North Anna 3 COLA

Slides for Discussion with NRC
Response to NRC January 15, 2016
Questions on Review of December 2015
FSAR Markups

February 3, 2016

ASME Code and ACI 349-01

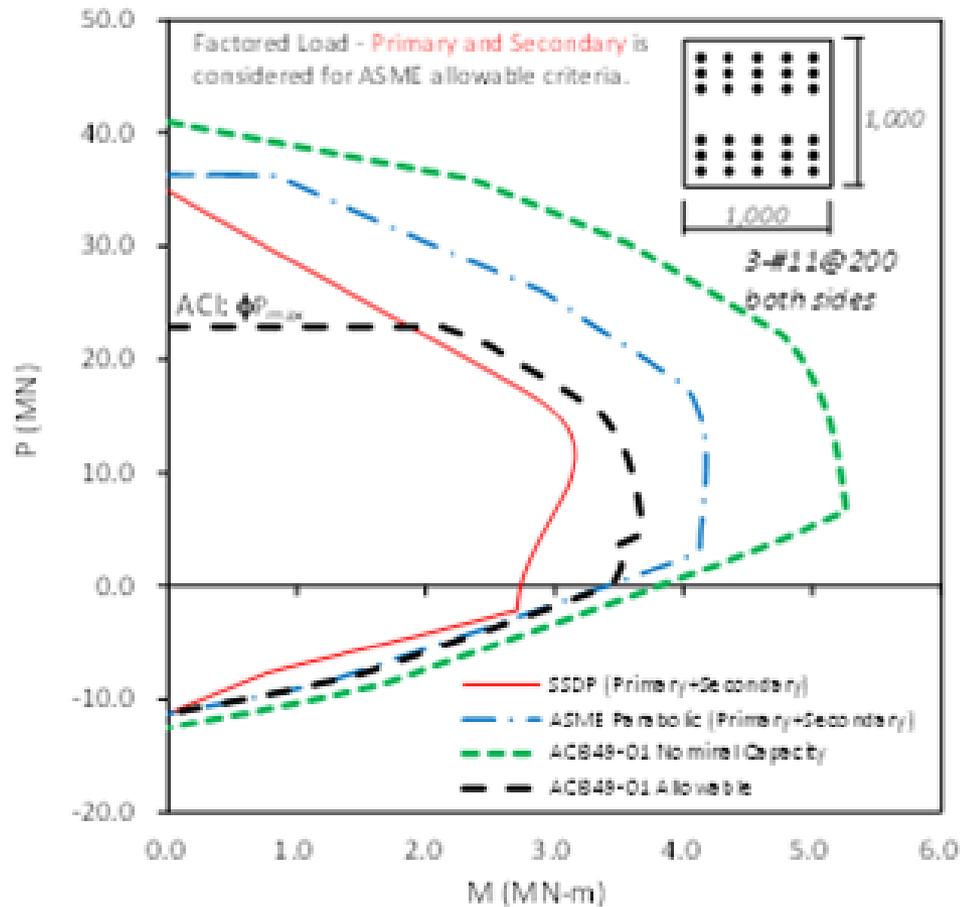
Justification would be needed for this change because, the reason the more limiting criterion was placed in the DCD is that the containment is integrally connected to the RB (unlike other containments) and thus, the RB provides support and interacts with the containment. During design certification, the applicant specified this criterion to address this issue. While the revised criterion seems reasonable for structural members sufficiently distant from the RB / containment interface (e.g., FB where an overstressed condition was identified), justification would be needed to completely revise the criterion as defined above.

- FSAR statement quoted in Question d) was evaluated
 - Justification was determined to be overly generalized
 - Dominion agrees that NRC would need additional information to approve approach set forth in FSAR Section 3.8.4.5, as currently written
- Further assessment of the issue has resulted in a revised approach

- For ASME reinforced concrete section analysis, multiple concrete stress-strain relationships are allowed by Code (CC-3511.1e) for factored loads:
 - linear, parabolic, or any curve backed by test data
- For ACI 349-01 reinforced concrete section analyses, rectangular stress block is used
 - Provides the same section strength as a parabolic stress block

- When structural elements are identified as exceeding the conservative SSDP-2D limits, a check using ACI 349-01, along with a P-M curve applicable to the structural element, will be used to demonstrate that both ASME Code and ACI 349-01 acceptance criteria are met
- Structural evaluation reports will include the basis and justification that the acceptance criteria are met
